VD Mechanism
for D-550/720/850/900
SDT-9600/9610/7785

SERVICE MANUAL

No. 1081

July, 1978

SUBJECT Modification of the Head Plate Spring on the VD Mechanism

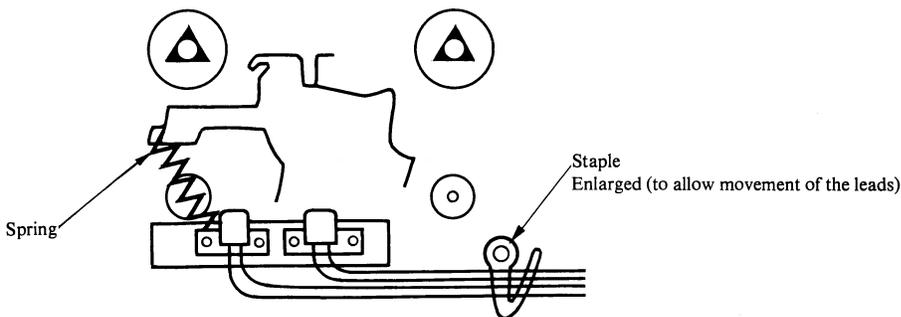
Due to hardening of the head lead wires at low temperatures some heads do not advance to the normal position on pressing the playback button, therefore the head plate spring has been changed. In addition, at the same time as spring replacement, the wiring clamp shown in the figure below has been enlarged to allow freedom of movement of the leads.

No.	Parts No.	Description	FOR Y Japan	*	Parts No.	Description	FOR Y Japan
	6302221	Spring		— A B	6324436	Spring for D-550AU/RW/ W/BS/FS/U D-720C/RW SDT-7785E/F/S	
				— A B	6300031	Spring for D-720U/AU/ W/FS SDT-9600H/C	
				— A B			
				— A B

SUBJECT VD Mechanism Brake Adjustment

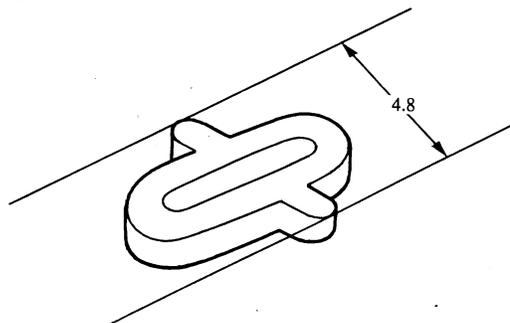
During prolonged used of the pause function, low brake torque causes tape slackness to occur; therefore the
brake rubber has been modified.

No.	Parts No.	Description	FOR ¥ Japan	*	Parts No.	Description	FOR ¥ Japan
	6586072	Brake rubber		$\overleftarrow{A} B$	6586071	Brake rubber for D-550AU/ RW/W/BS/FS/U D-850U/C/BS/FS/W/AU SDT-7785E/F/S	
				$\overleftarrow{A} B$	6586002	Brake rubber for D-720U/AU/W/ FS/C/RW SDT-9600H/C	
				$\overleftarrow{A} B$			
				$\overleftarrow{A} B$

SUBJECT Discharge Noise Created by the VD Mechanism — Countermeasures

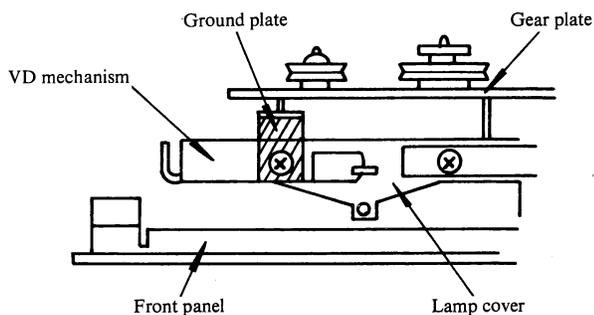
Electrical discharge noise which is caused by the charge generated by friction produced during rotation of the take-up pulley and fly-wheel belt pulley, etc. is cured by installation of a ground plate, as detailed below.

To mount the ground plate: Remove the screw at the left side of the lamp cover, and insert the ground plate between the VD mechanism and the lamp cover. Tighten the new assembly.

SUBJECT Modification of the AS Control Spring for the VD Mechanism

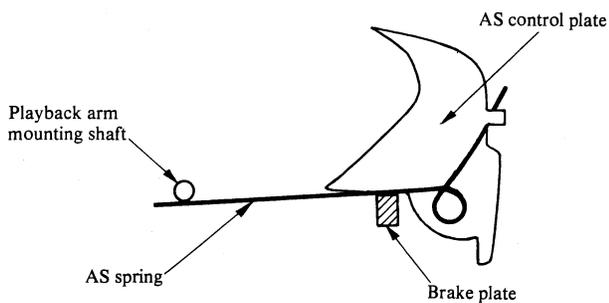
To improve the efficiency of installation and to prevent the spring shipping out of its location.

No.	Parts No.	Description	FOR Y Japan	*	Parts No.	Description	FOR Y Japan
1	7295951	AS control plate		$\overline{A B}$	6307924	AS control spring for D-550AU/ RW/W/BS/FS/U SDT-7785	
2	6308301	AS spring		$\overline{A B}$	6307921	AS control spring for D720U/ AU/W/FS/C/RW SDT-9600H/C	
				$\overline{A B}$			
				$\overline{A B}$

SUBJECT Improvement of Auto Stop Malfunctioning

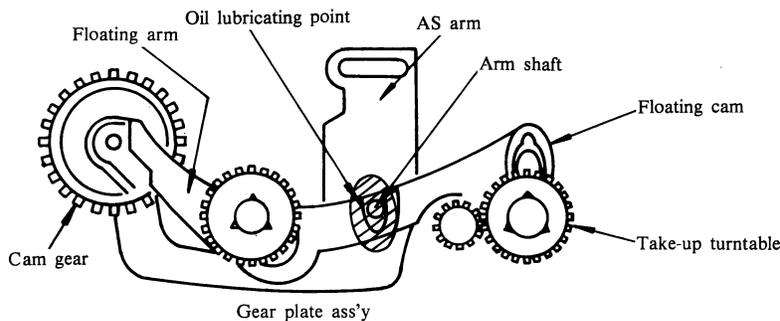
Tape transportation is stopped by operation of Auto stop mechanism in playback mode. To improve it the following modification has been made.

1. Remove gear plate ass'y. Lubricate pan motor oil to contact surface of floating arm and arm shaft and AS arm.
2. Make sure that AS arm moves smoothly.

SUBJECT Improvement of Mechanical Sound

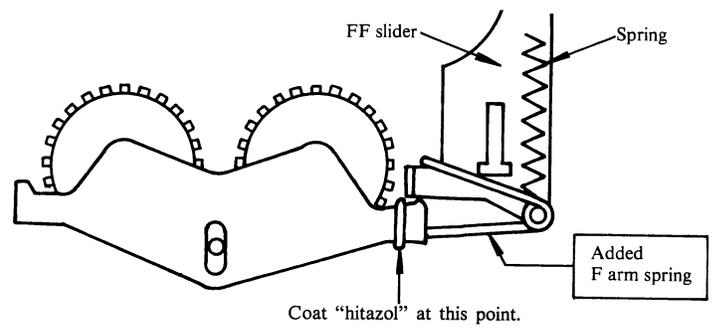
Mechanical sound is produced from F gear of gear plate. To improve it, the following modification has been made.

No.	Parts No.	Description	FOR ¥ Japan	*	Parts No.	Description	FOR ¥ Japan
	6308941	F arm spring		— A B			
				— A B			
				— A B			
				— A B

SUBJECT Improvement of Pause Mechanism

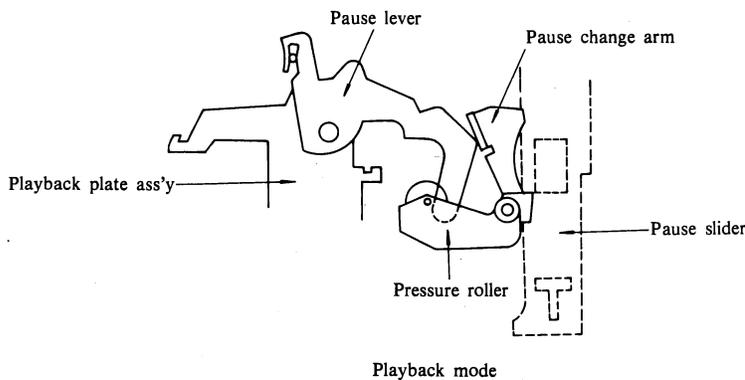
In former pause mechanism, when pause button was depressed to stop the tape transportation temporarily during playing back or recording, heads and pressure roller return to original position.

This caused slow tape speed at beginning when pause mode was released.

1. Heads keep touching tape surface.
2. Pressure roller comes away from capstan.

SUBJECT Improvement of Hum

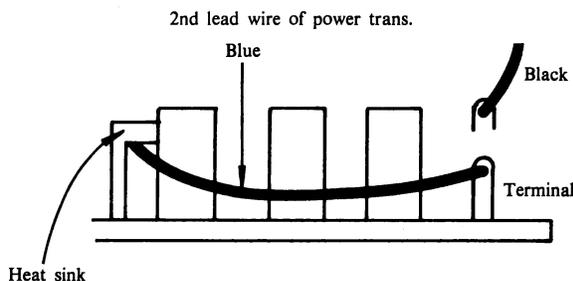
To decrease hum wiring of secondary wire (P.T) is changed.

Wire "Blue" is paralleled with "Black" on original model.

After changing, "Black" is left as in the original, and "Blue" is changed as below.

SUBJECT Improvement of Mechanical Sound

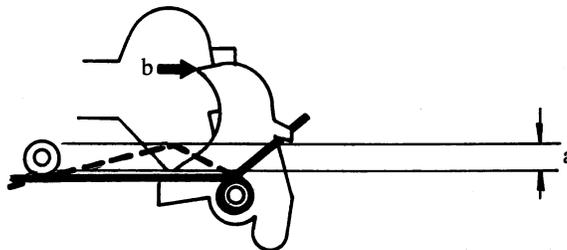
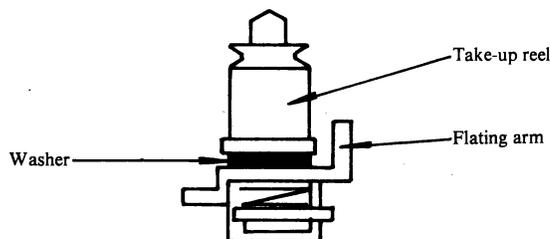
Mechanical sound occurs in STOP mode. To improve it, the following modification has been made.

1. Bend AS spring as shown by dotted line.

Dimension of "a" is 1-2 mm from AS control spring to point where AS control plate and chassis intersect.

2. Check tension at point "b" with tension gauge that AS control plate starts to rotate with 4-6 gram tension. If measured tension is not within 4-6 gram, readjust the bend of AS spring.
